Ventura County Community College District

SUBJECT: Addendum 2 – Bid 594 Fire Technology Apparatus Building Rough Grading and

Storm Drain Improvements

The attached reduced <u>Academy Rough Grade Clouded Drawings</u> have been added to this project and is posted on our website in full size format.

VCCCD FIRE ACADEMY, CAMARILLO CAMARILLO, CA

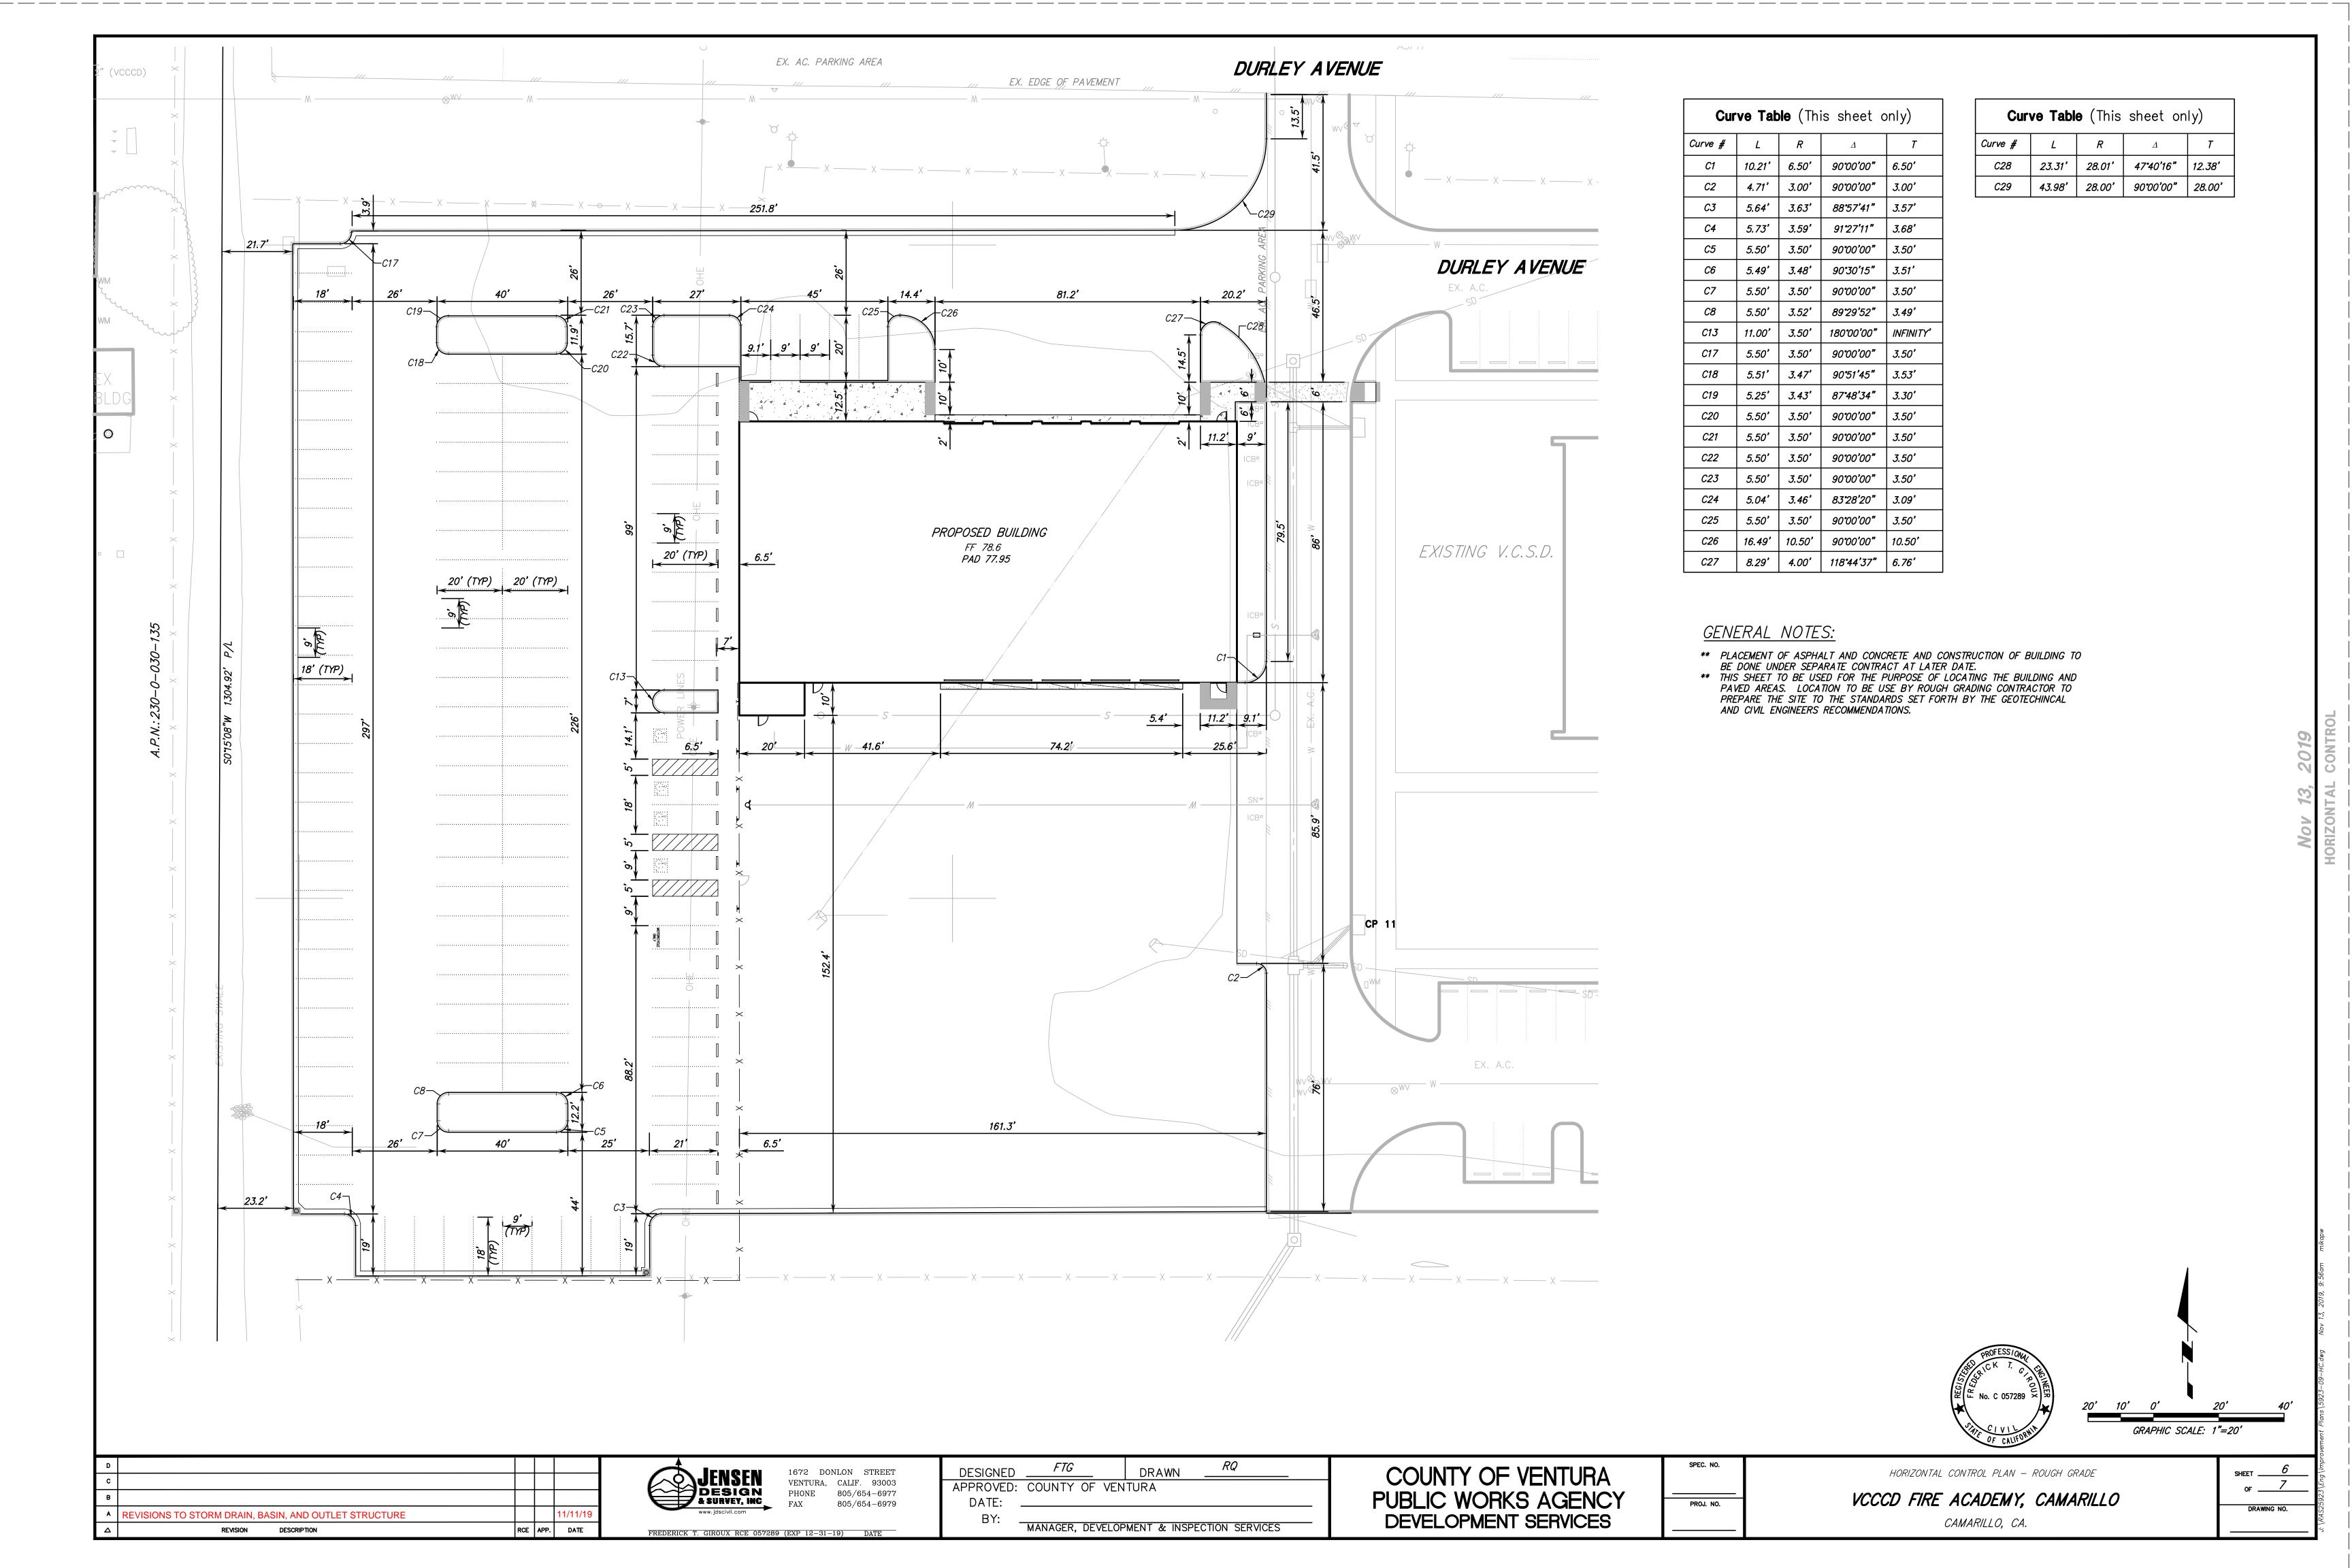
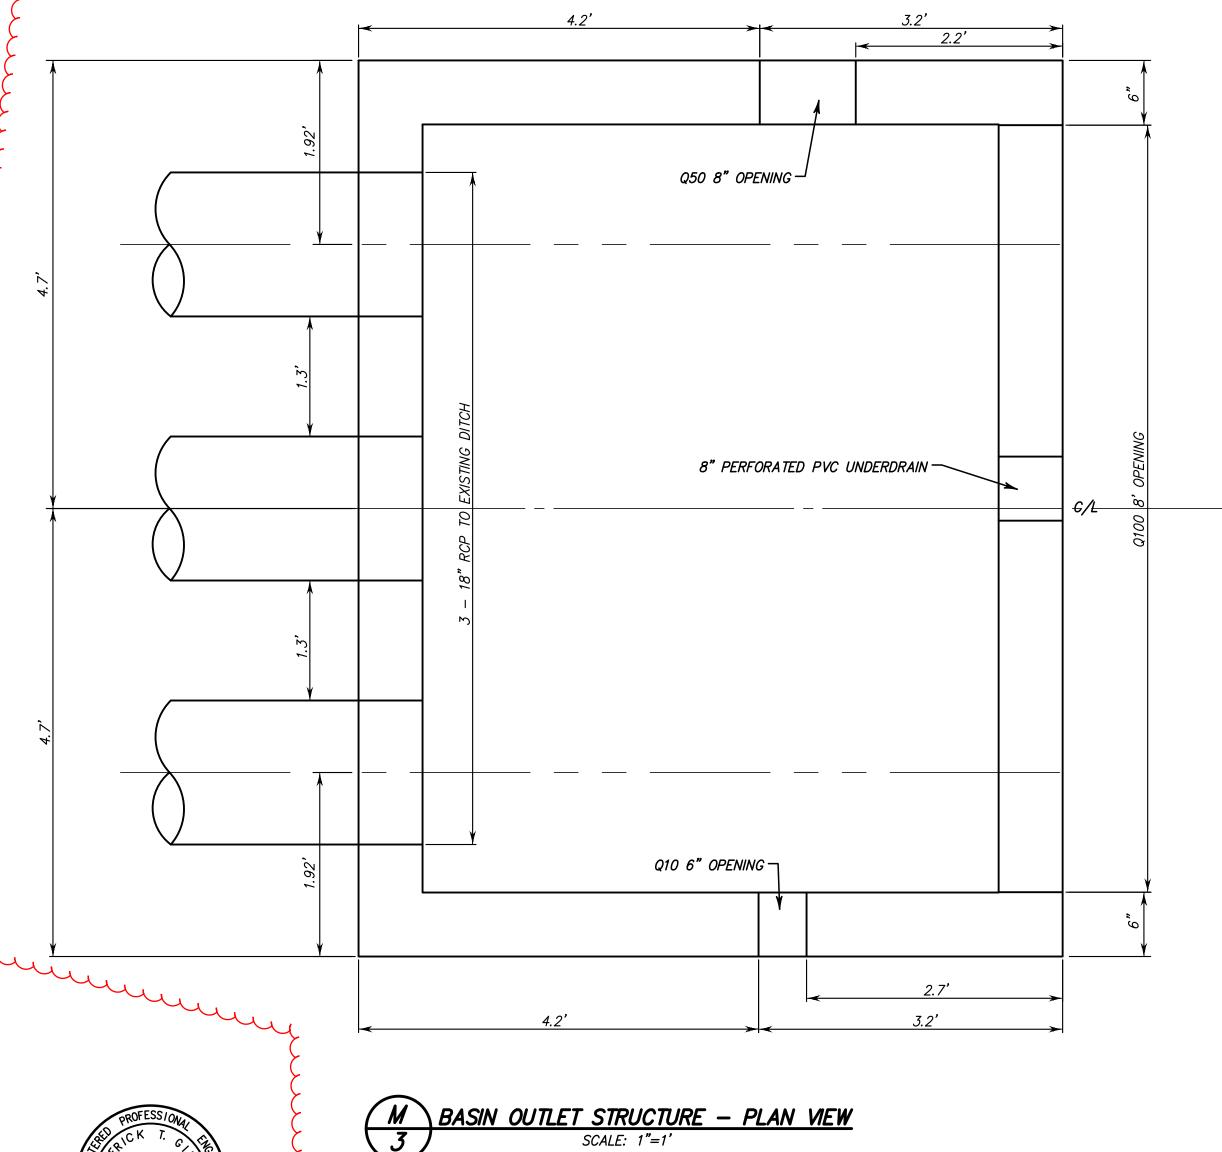
REVISIONS TO STORM DRAIN, BASIN, AND OUTLET STRUCTURE 11/11/	_
C	١.

IMPROVEMENT PLAN DETAILS - ROUGH GRADE

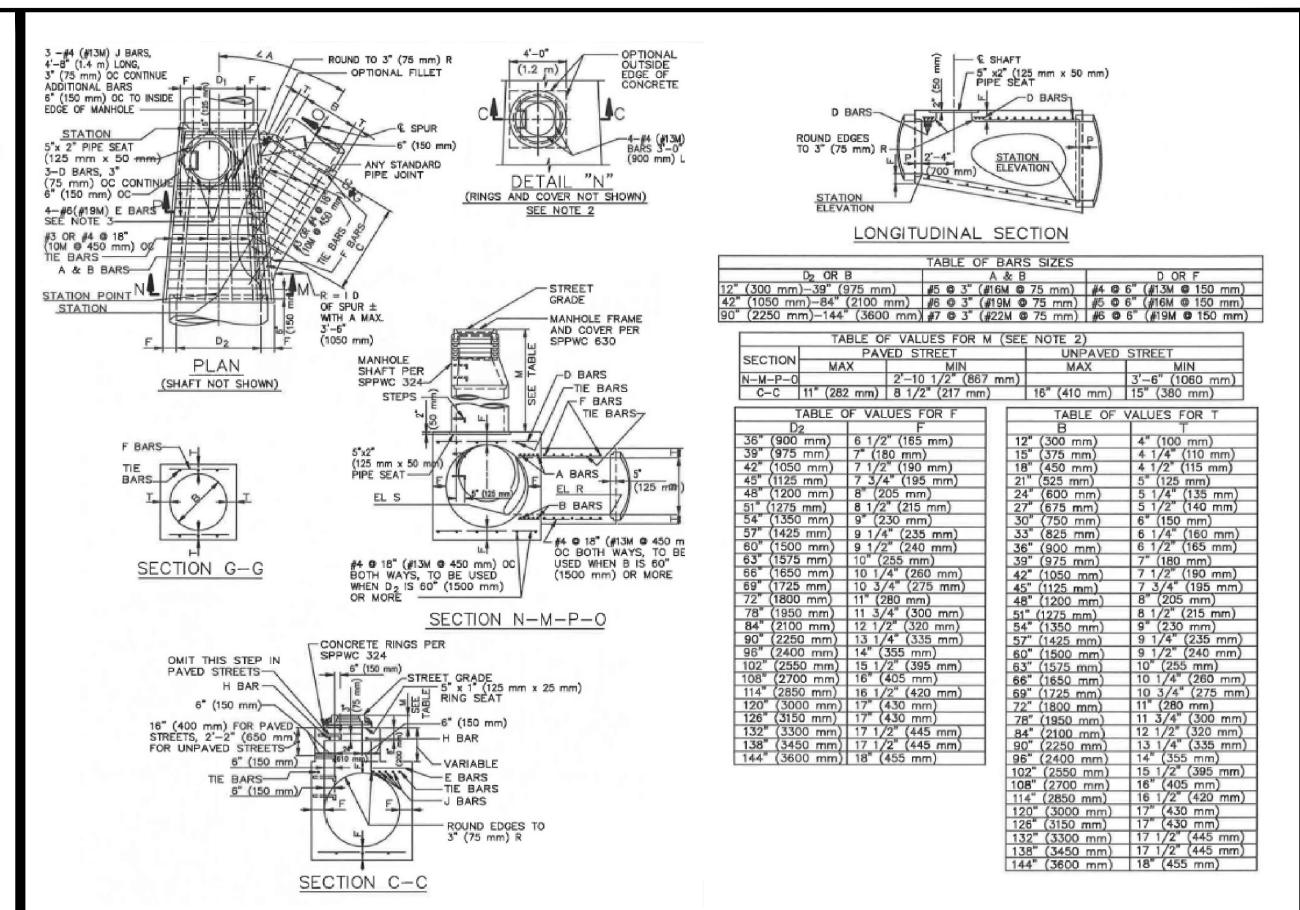
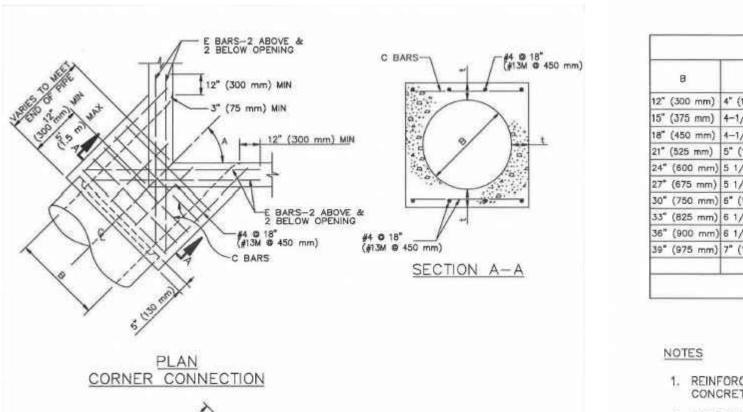
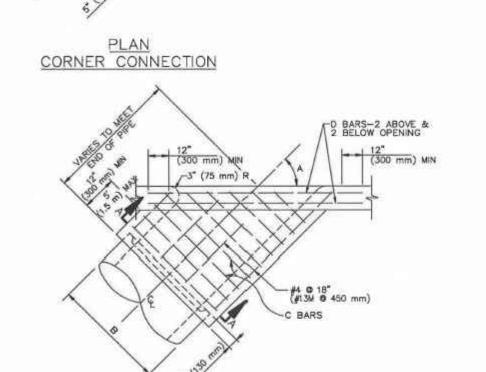
REVISIONS TO STORM DRAIN, BASIN, AND OUTLET STRUCTURE RCE APP. DATE
